## Town of Kittery Maine Planning Board Meeting January 9, 2020

### ITEM 1 – 8 Wentworth Street – Sketch Plan Review

Action: Accept or deny application. Approve or deny sketch plan. Owner/applicant, the Town of Kittery, requests consideration of a sketch plan for a three-story addition and related site improvements to the Rice Public Library located at 8 Wentworth Street (Tax Map 4, Lot 88) in the Mixed Use – Kittery Foreside (MU-KF) Zone. Agent is Ryan Kanteres, Scott Simons Architects.

Rice Public Library - Rendered Site Plan

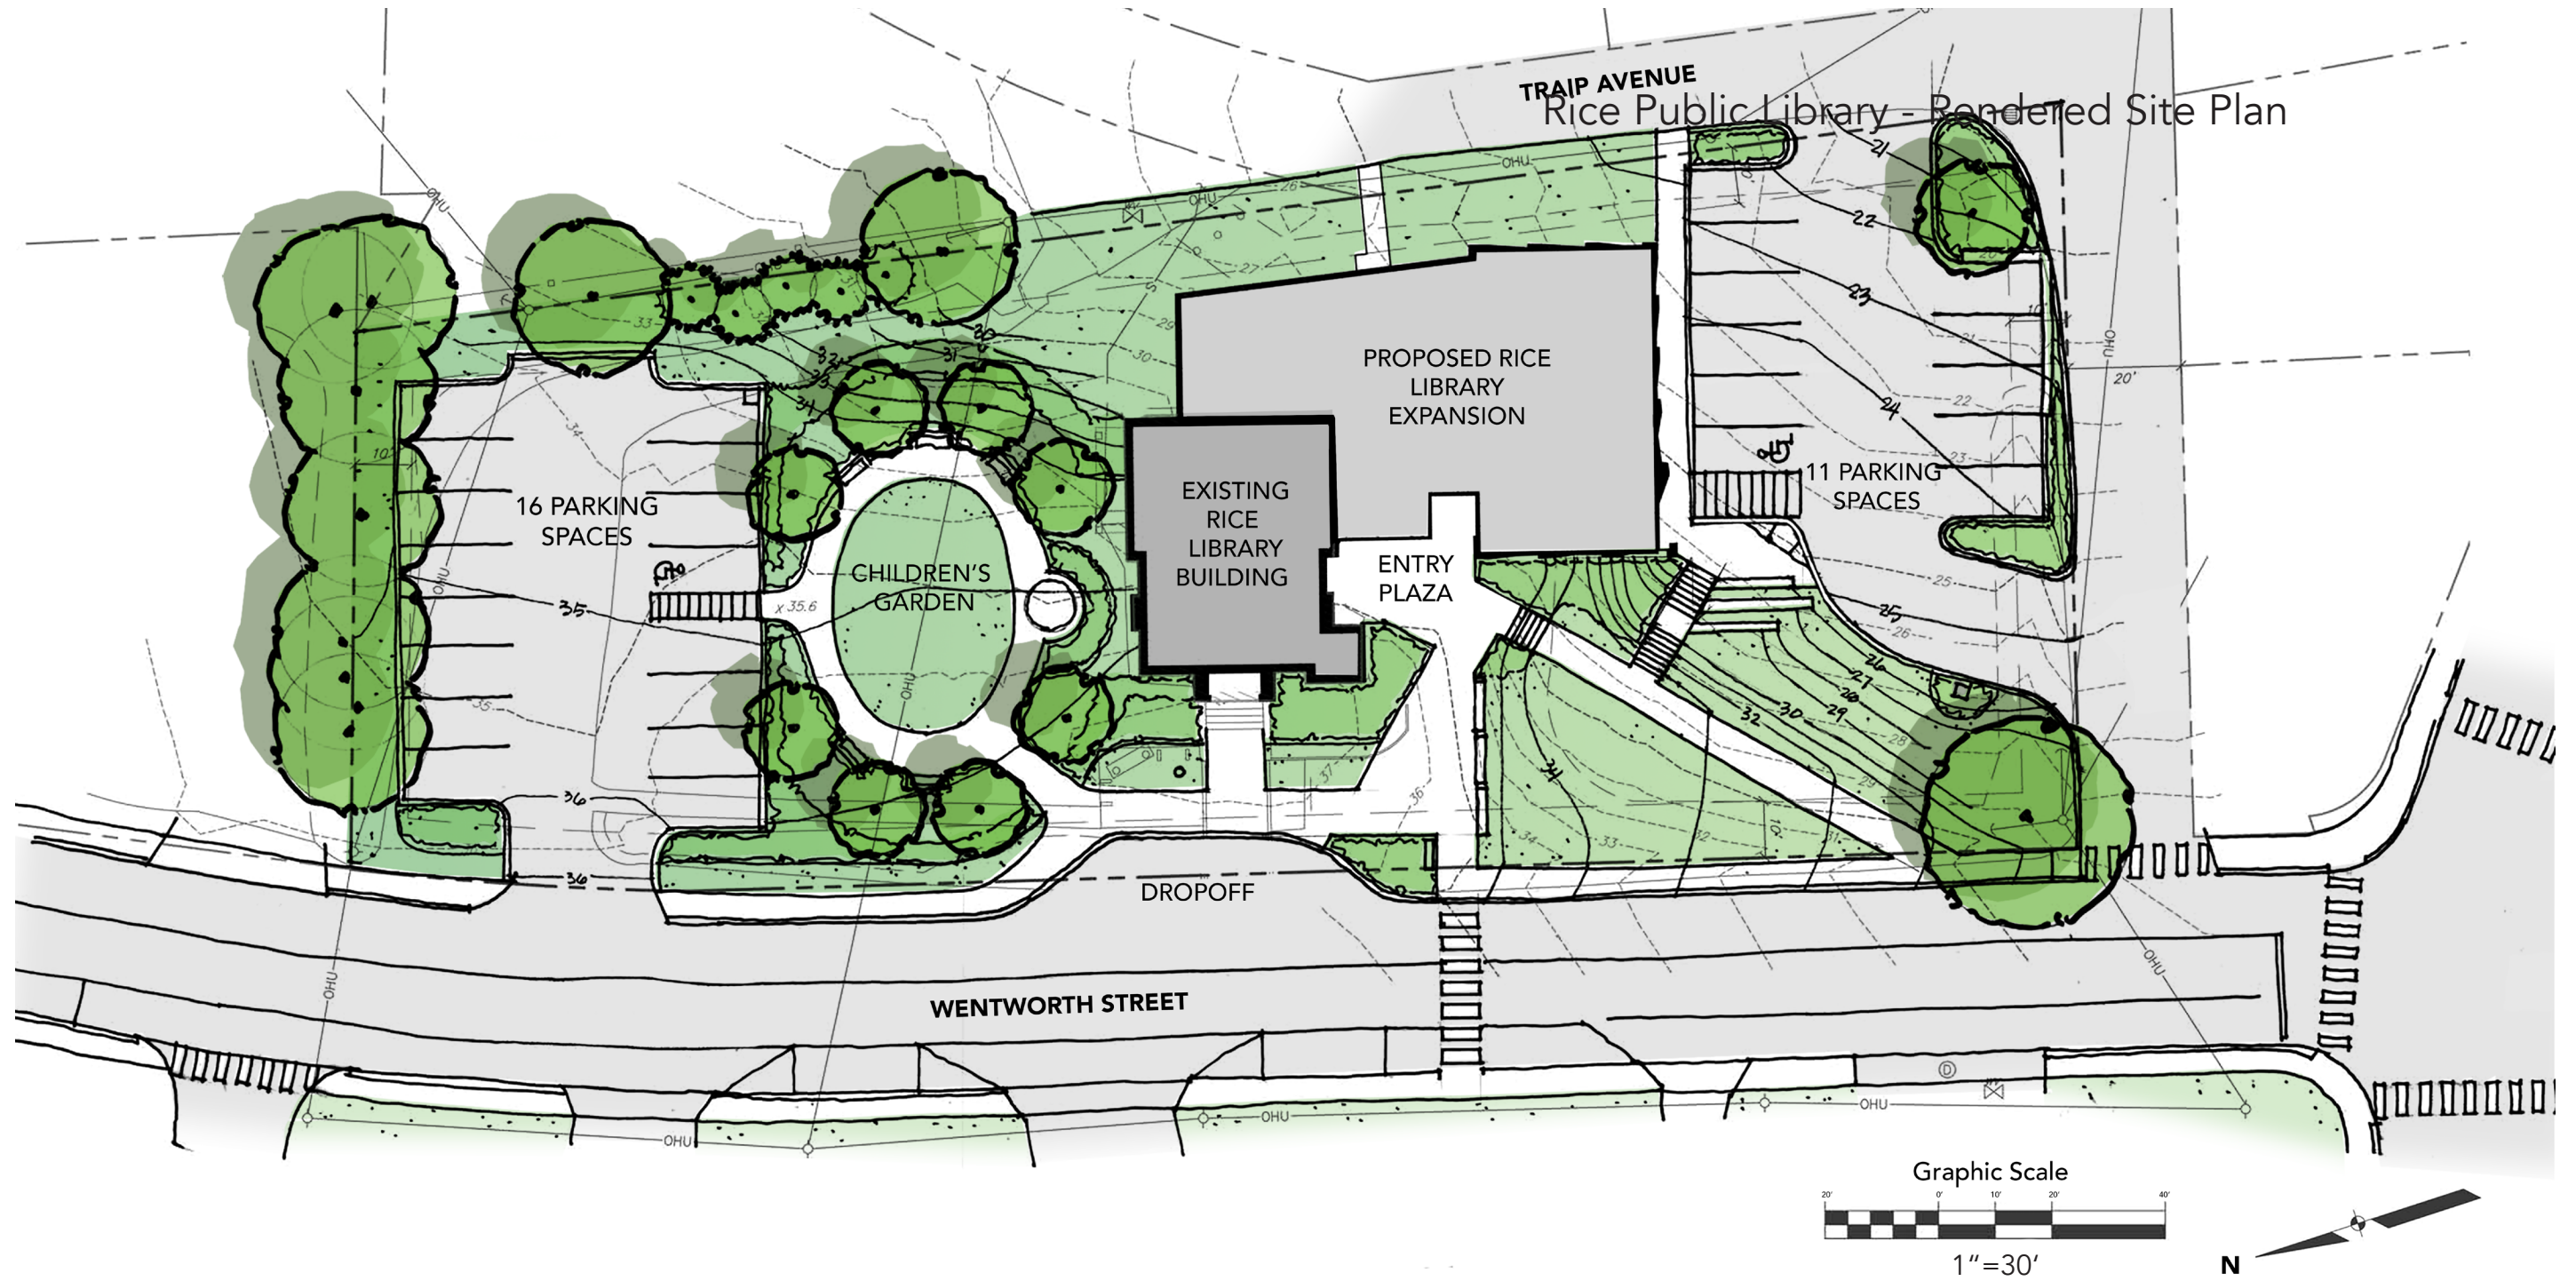
- c. According to 16.3.2.15.D.(4).(e) *Roof slope and shapes*, a hipped roof does not have to meet the 8:12 pitch. The largest area of roof proposed for the expansion is a hipped roof although it does appear that a portion of the roof, where it connects to the original building may be flat, or nearly so. This would not meet the standards in e [3], *Roof slope and shapes*. Additionally, e[2] states that *roof pitch of elements that link buildings or portions of buildings must be the same or greater than the pitch of the roofs on buildings that are being linked.* As can be seen from the architectural drawing provided, the pitch is less if an “element” is where the old and new buildings meet. Finally, e[4] states *the roof pitch of additions or wings must be similar to the pitch of the primary roof.* If the primary roof is the roof of the original building, the pitch of the main body of the existing building's roof appears to be greater than the proposed expansion. The Applicant has applied to the Board of Appeals for relief via a miscellaneous variation request.

1. There isn't a specific special parking standard for municipal buildings listed in the MU-KF zone or in 16.8.9.4.D Parking Standards. Instead, the Applicant is basing the number of parking spaces on public floor area and the number of full time equivalent (FTE, mistakenly called FFE on the plans) employees. The floor plans were not submitted as part of sketch plan nor were the number of FTE employees. This information can be submitted with the preliminary plan.

3. The Applicant is proposing one parking space for every 350 sf of public floor area and one parking space for every two FTE employees. The Applicant is proposing 27 off-street parking spaces plus two dedicated short-term parking spaces on Wentworth Street which presumably are located where the "Drop-Off Area" is noted on the plans. The southern parking lot is proposed to be paved (it is currently gravel) with 10 parking spaces + one ADA-compliant space while the northern parking lot is proposed to accommodate 15 parking spaces + one ADA-compliant space. The number of ADA-compliant parking spaces meets the requirements for each parking lot (1 ADA-compliant space for up to 25 parking spaces).
